APPENDIX M
PUBLIC CONSULTATION

Claremont Drainage Plan

TPB168152 – Claremont Drainage Plan PIC1 Resident Comment Summary

EXISTING STORM DRAINAGE PLAN

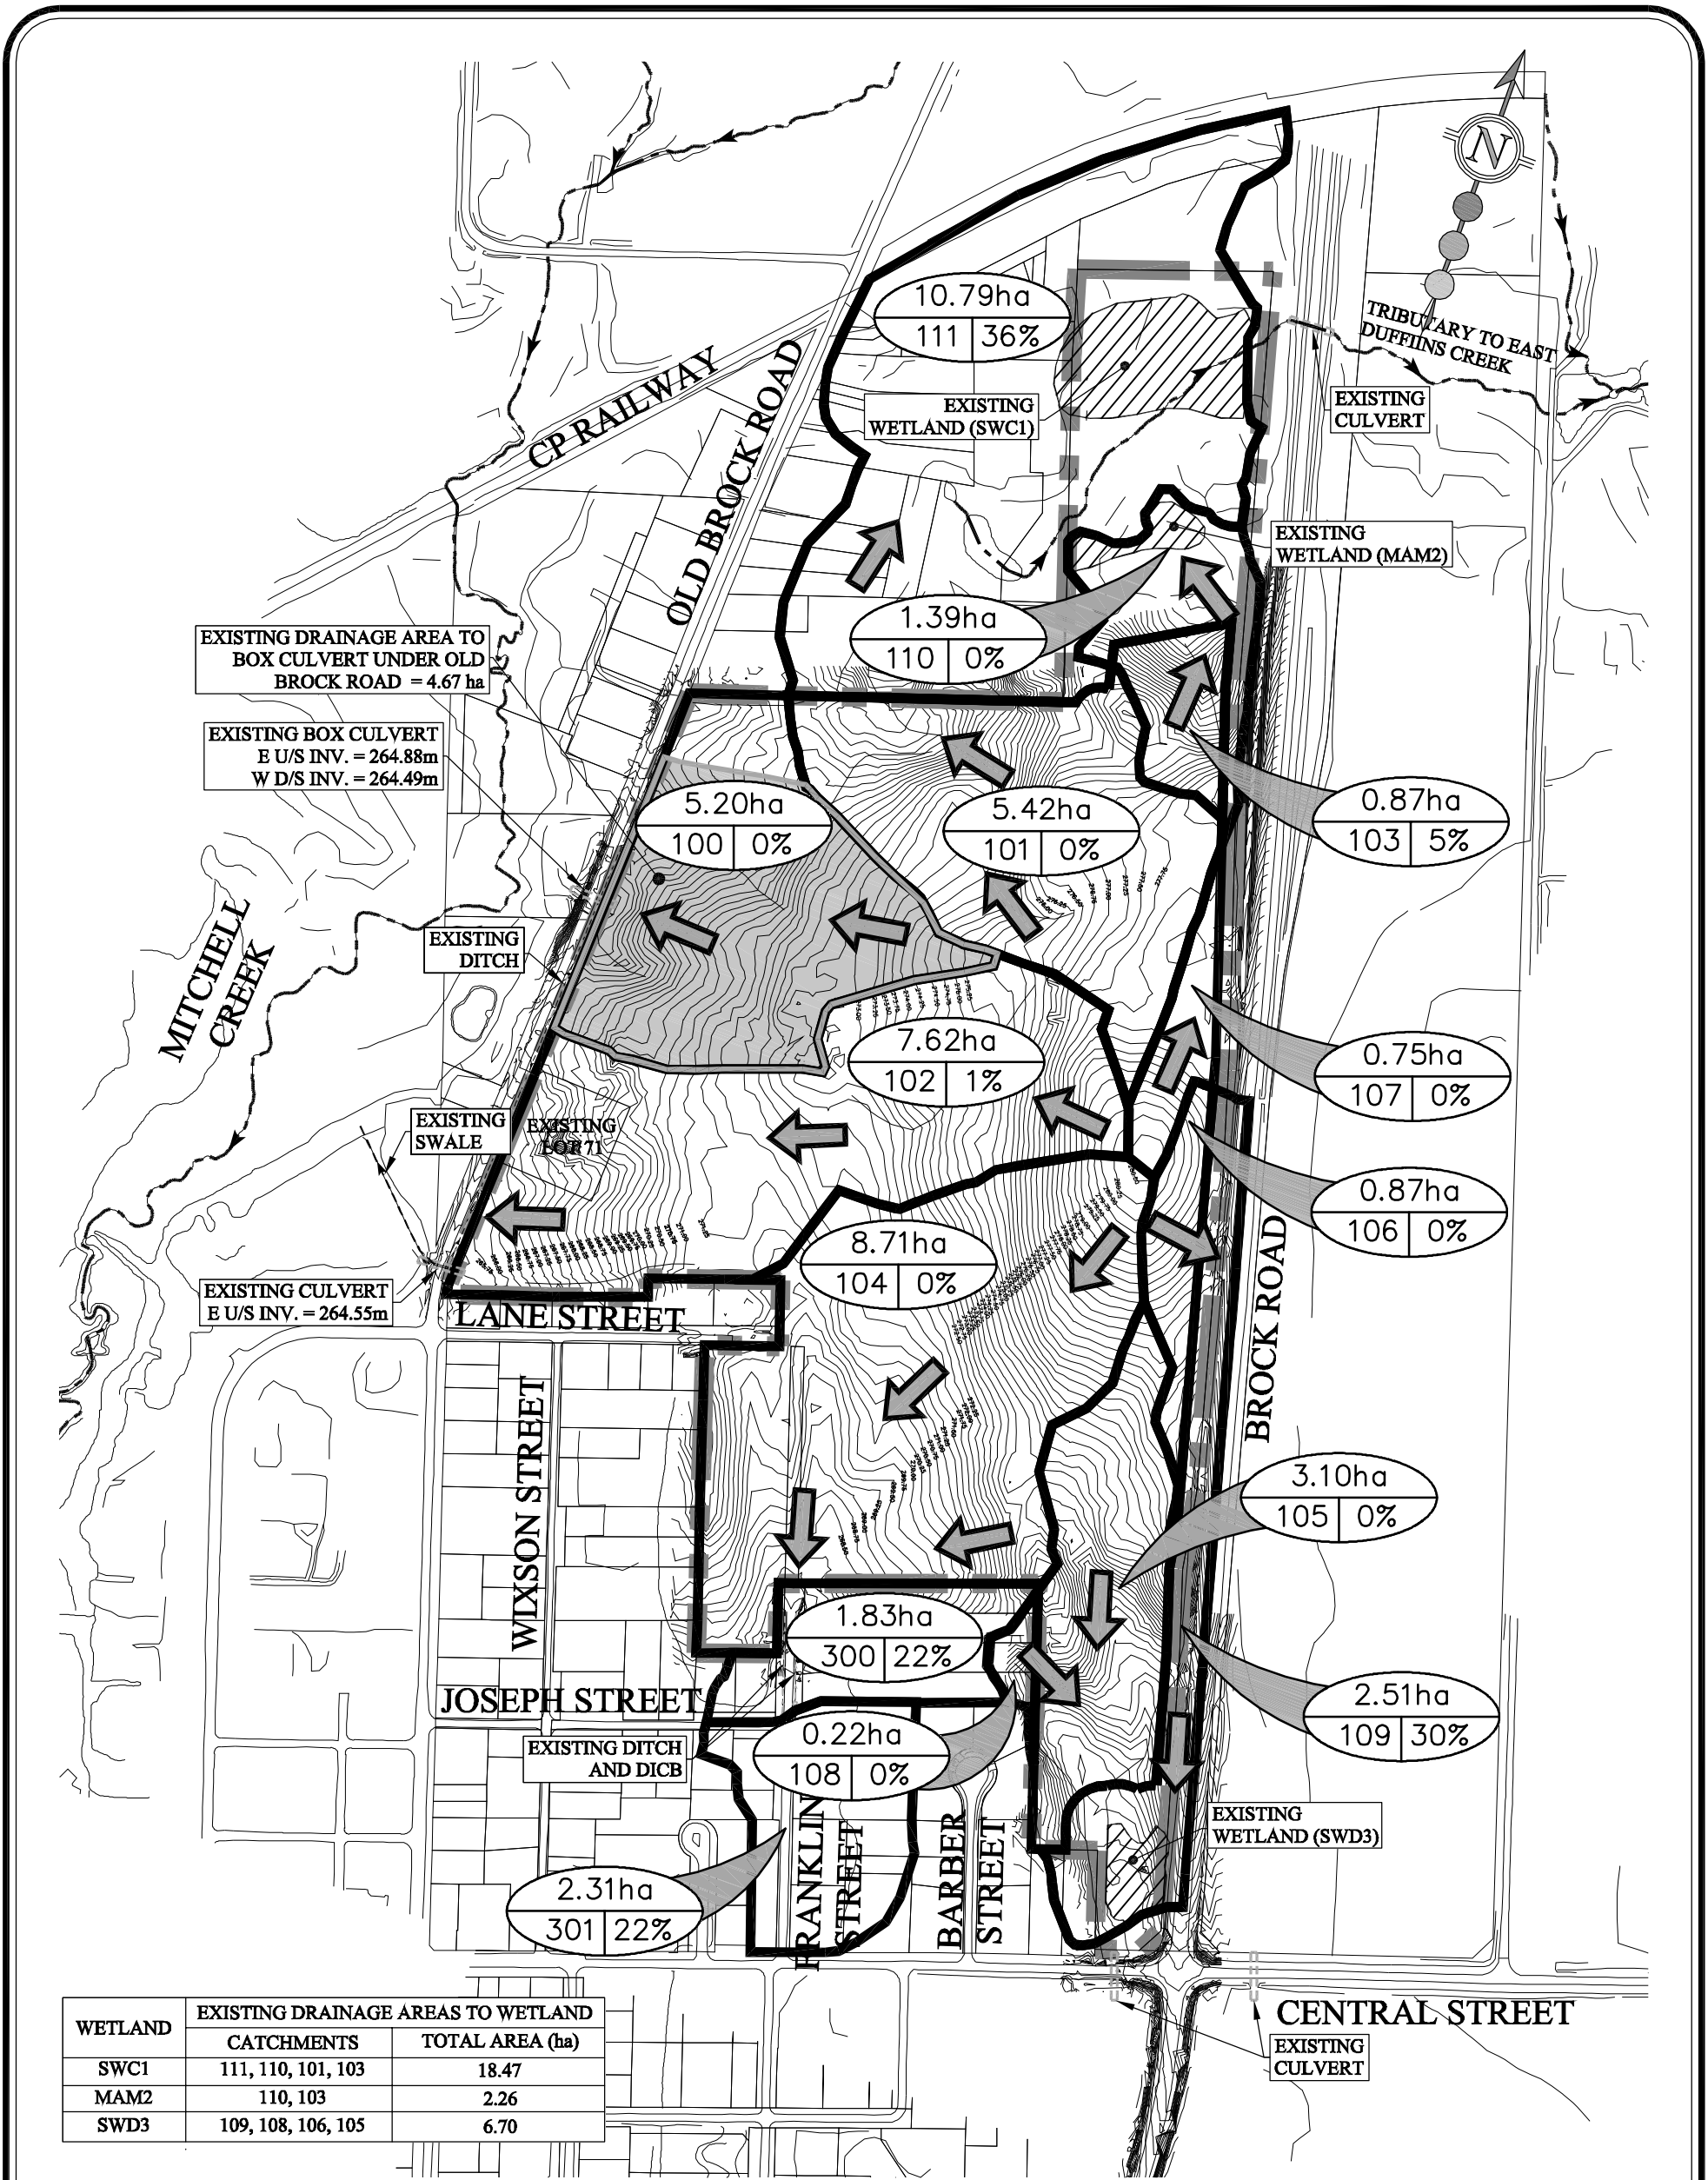
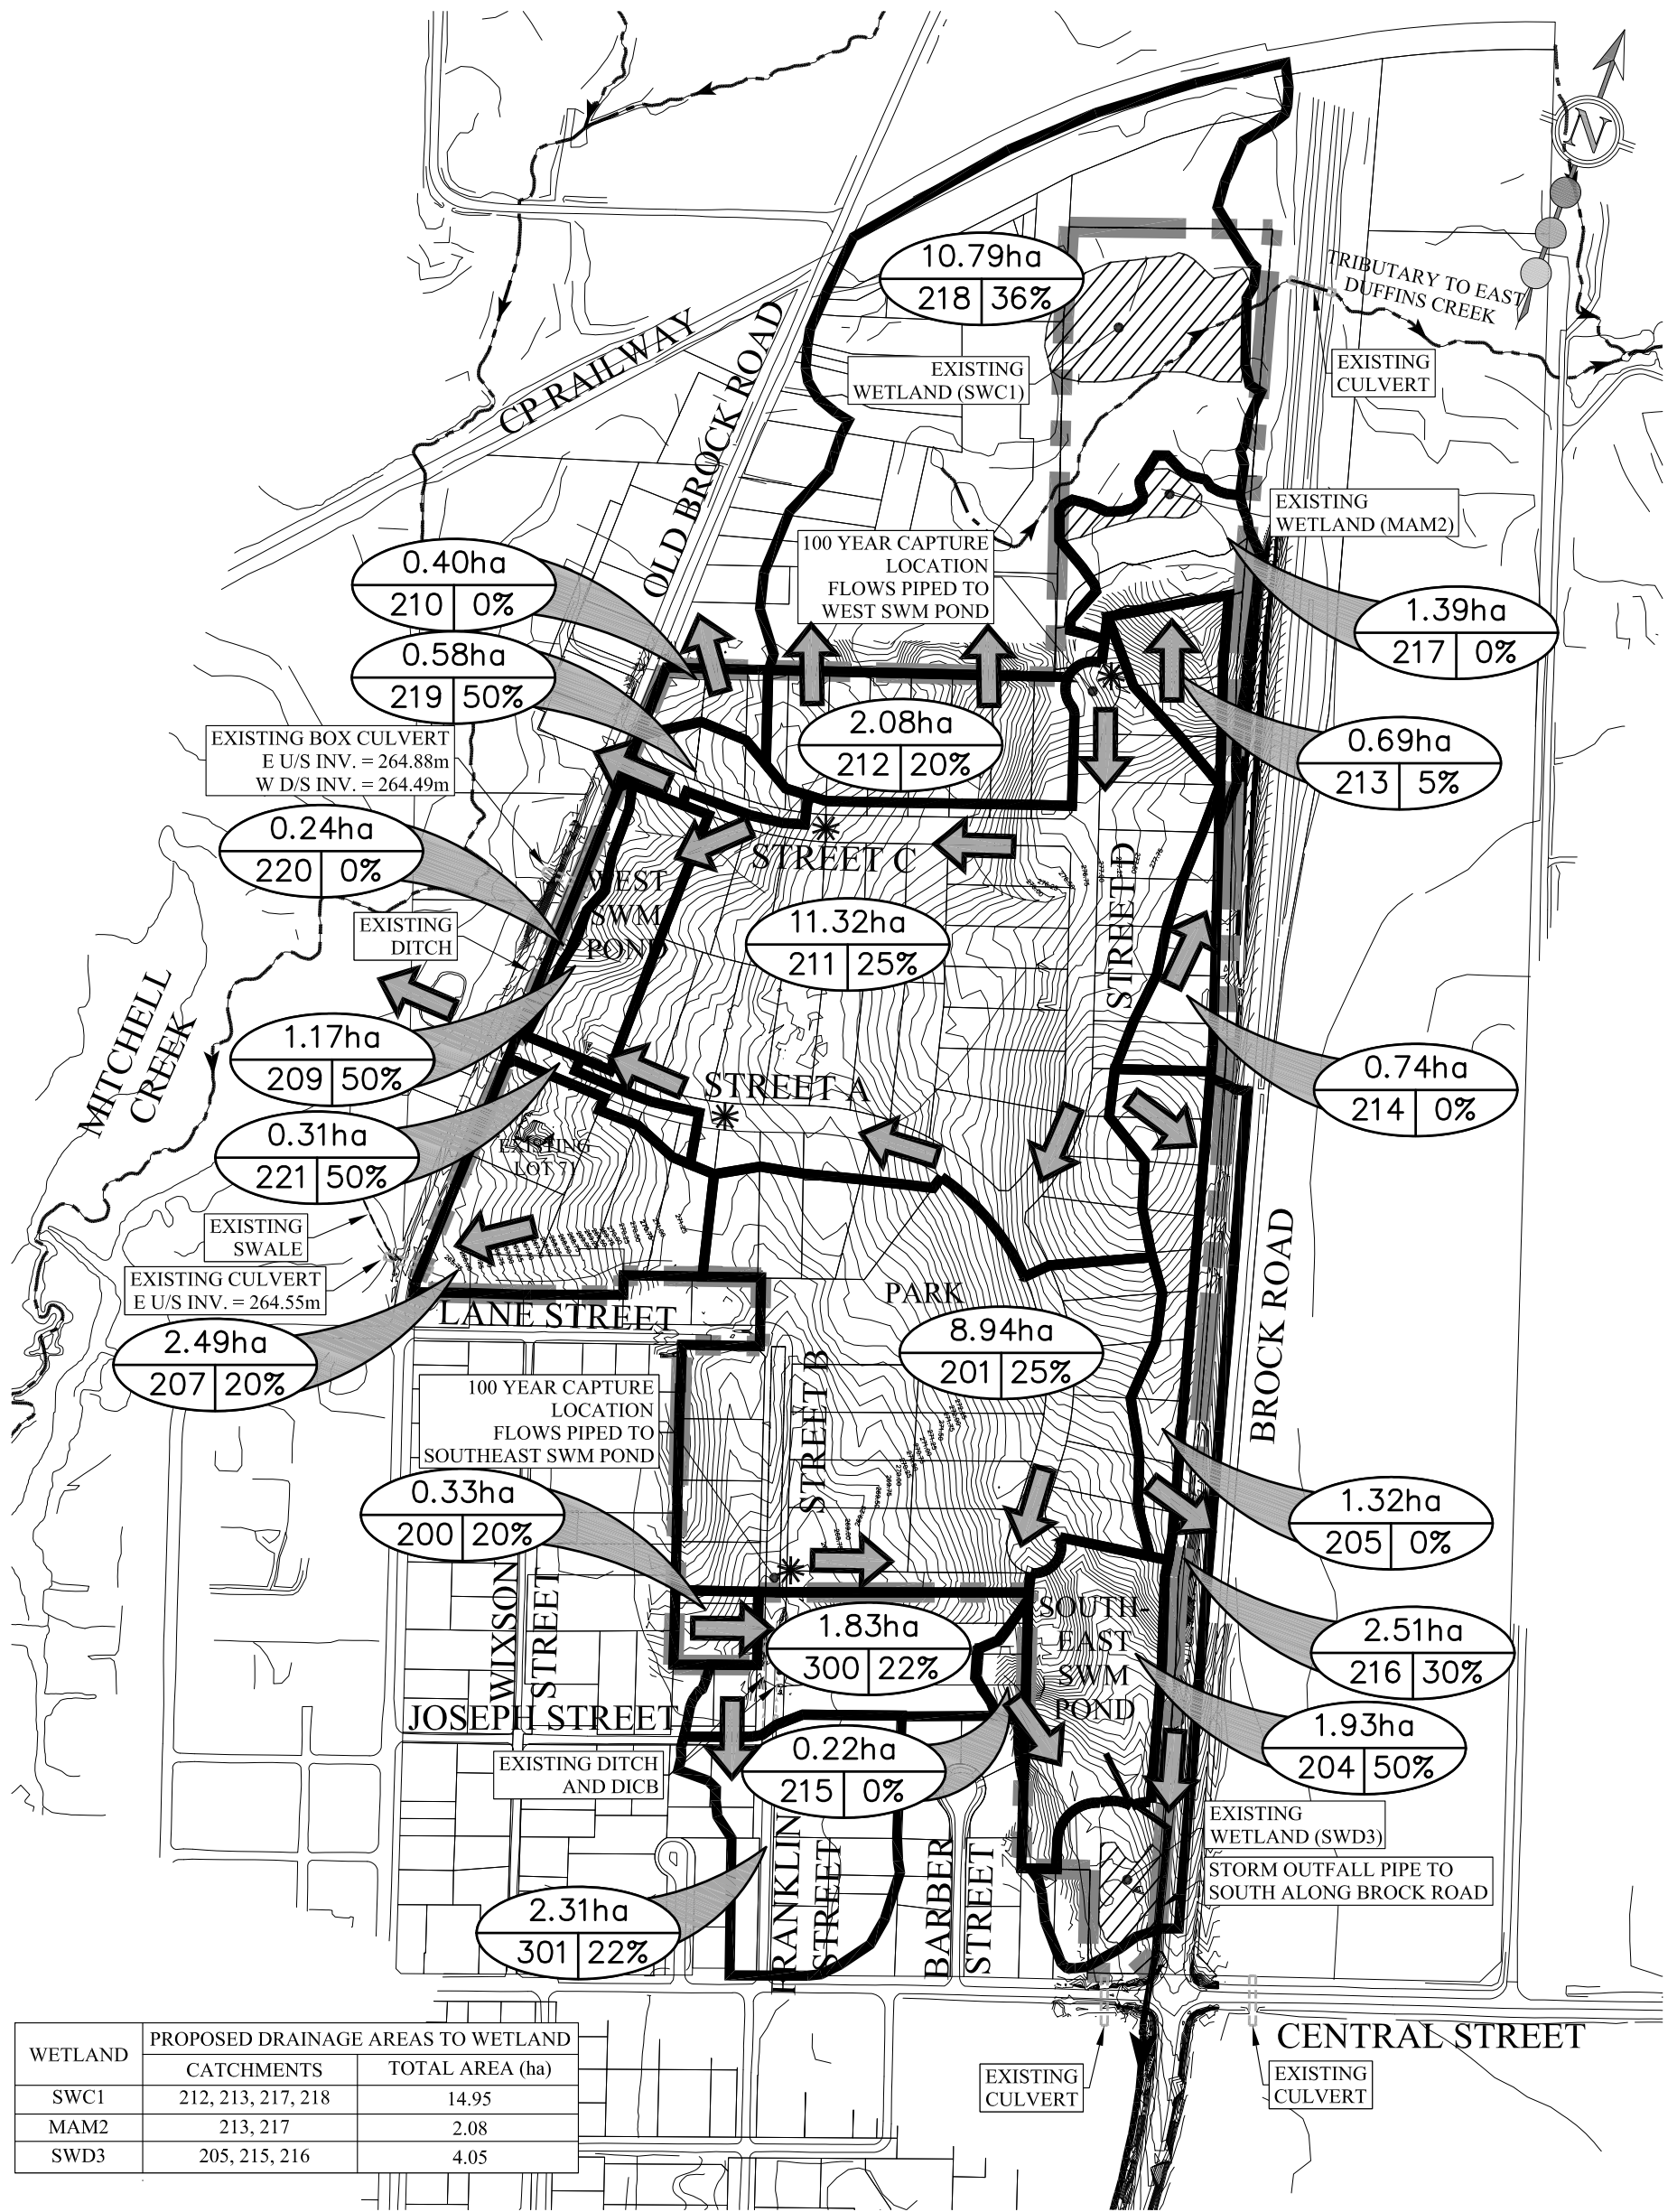
- ➔ *The study area should be expanded to include the limits of the existing contributing drainage from all the external lands, as they are part of the Claremont drainage system. There is approximately 8.7 ha of the CDI property that currently drains south to the north limit of Franklin Street, as illustrated in the attached Existing Storm Drainage Plan from the Functional Servicing Report prepared by SCS (March 2018);*

It is also evident that the EA has not included our request to consider the proposed drainage diversion of runoff from the CDI lands that currently outlets to Franklin Street to a proposed SWM facility adjacent Brock Road (which is proposed to outlet to the westerly Brock Road ditch system, south of Central Street) as one of the potential solutions. This proposed drainage diversion was documented in a revised Functional Servicing and Stormwater Management Report (FSSR), prepared by SCS Consulting Group Ltd., dated July 2021, that was included in a revised Draft Plan of Subdivision application submission to the City in July 2021.

As per our past discussions and as documented in the July 2021 FSSR, **this proposed diversion will result in a significant (97%) reduction in the 100 year peak flows and runoff volumes to Franklin Street, dramatically improving the current drainage condition and providing a significant public benefit.** Copies of the Existing Storm Drainage Plan and Proposed Storm Drainage Plan from our July 2021 FSSR have been attached for your reference.

- The Claremont Drainage Plan Study was undertaken by the City to complete a comprehensive analysis of the existing drainage system (minor and major) for the area of the Hamlet of Claremont serviced by storm sewers, therefore the study boundary was established to reflect the central part of the Claremont. However, since the existing system analysis is based on the overall contributing drainage catchments, the undeveloped external drainage area north of Franklin Street has been incorporated into the PCSWMM model. The area has been divided into two sub-catchments (ref. attached screen shot of the PCSWMM model) totaling 8.3 ha (+/-); the delineated drainage area slightly differs in comparison to the SCS delineated external drainage area of 8.7 ha (+/-). The Study boundary will remain as is.

- A copy of the PCSWMM model will be available upon request once the Municipal Class EA report is finalized.
- The Claremont Drainage Plan Municipal Class EA Study includes evaluation of all possible alternative solutions based on the existing conditions. Future developments (draft plan or site plan approved) were not included in the study,

as recommended proposed alternative solutions shall not rely or depend on any private development schedules, business plans, etc. If the proposed CDI lands development is approved and constructed prior the Claremont Drainage Plan implementation schedule, any changes to the external drainage area will be considered at the detailed design stage of the implementation plan.
